Addendum No. 2
Rock River Water Reclamation District
Substation 3-6 Electrical Upgrades
Capital Project No. 2023

This Addendum Number 2, dated June 13, 2019, for the above referenced project, supersedes all contrary and conflicting information in the specifications and contract documents, which are hereby supplemented or revised as follows:

EXISTING SITE PIPING PROFILE

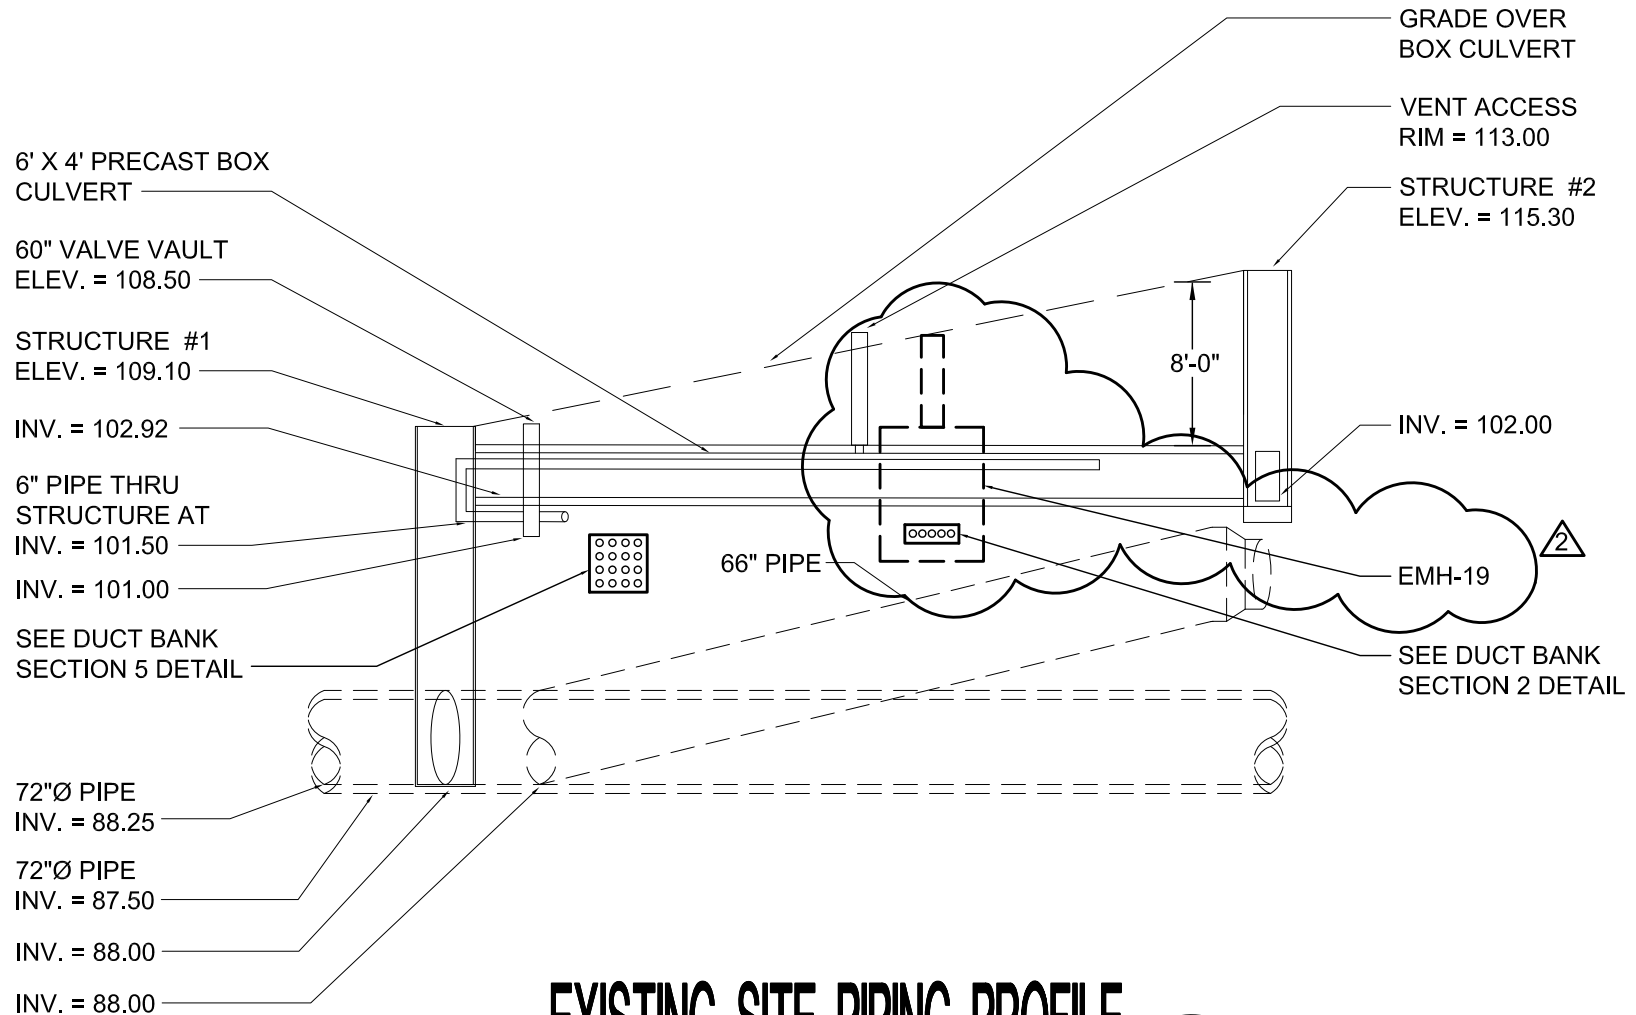
REPLACE Existing Site Piping Profile detail. See attached ADE2.1
